Access Compliance Report

Public Rights-of-Way

Intersection ID: 43685	Main Street: HARLINGTON_LN	Cross Street: TODDINGTON_LN	Location: SE
ADA ID: 2E1CFA759B89	Ramp Type: BlendTrans1	Initial Pass/Fail: Fail	Overall Compliance: No
Severity Score: 18.75			
Codes/Mitigation Info/Possible Solution		Field Measurements/Component Compliance

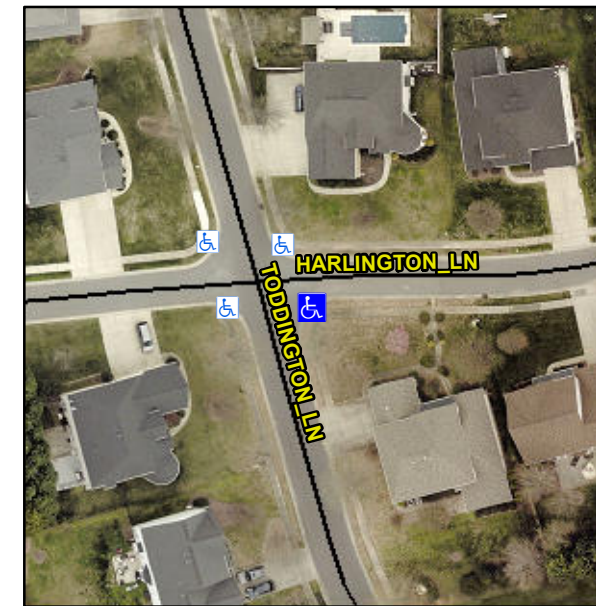
Not Found, R304.5.1, R304.5.3

Compliance	Description	Data	Compliance	Description	Data
N/A	Ramp Length (in)	53.0	Yes	BlendTrans Slope (%)	2.1
No	Ramp Width (in)	35.5	No	BlendTrans XSlope (%)	2.3
N/A	Flare Type LT	N/A	N/A	Flare Type RT	N/A
N/A	Flare Slope LT (%)	N/A	N/A	Flare Slope RT (%)	N/A
N/A	Flare Traversable LT?	N/A	N/A	Flare Traversable RT?	N/A
N/A	Landing Length (in)	N/A	N/A	DWS Provided?	N/A
N/A	Landing Width (in)	N/A	N/A	DWS Contrast?	N/A
N/A	Landing Slope (%)	N/A	N/A	DWS Length (in)	N/A
N/A	Landing X Slope (%)	N/A	N/A	DWS Full Width?	N/A
N/A	Landing Curb? (Y/N)	N/A	N/A	DWS Offset (in)	N/A
N/A	Shared Landing?	N/A			
N/A	Gutter Ponding?	N/A	N/A	Gutter Slope (%)	N/A
N/A	Gutter Lip Ht (in)	N/A	N/A	Gutter X Slope (%)	N/A
N/A	Painted X Walk1?	No	N/A	Painted X Walk2?	No
	X Walk 1 Direction	To N		X Walk 2 Direction	To W
	X Walk 1 Width (in)	N/A		X Walk 2 Width (in)	N/A
	X Walk 1 Slope (%)	0.2		X Walk 2 Slope (%)	2.3
	X Walk 1 X Slope (%)	1.0		X Walk 2 X Slope (%)	0.5

N/A	Ramp inside XWalk1?	N/A	N/A	Ramp inside XWalk2?	N/A
	Road Slope (%)	1.1		Clear Space?	N/A
	Road X Slope (%)	1.6	N/A	Clear Space to XWalk (in)	N/A
N/A	Any Obstructions?	N/A	N/A	Storm Grate/Utility Hazard?	N/A
	Obstruction Type			Storm Grate/Utility Type	
		N/A			N/A
			Yes	Surface Condition? (G/P)	Good
			No	Curb Slope (%)	11.4

Remove & Replace Curb Ramp With Two New Directional Ramps or Equivalent.
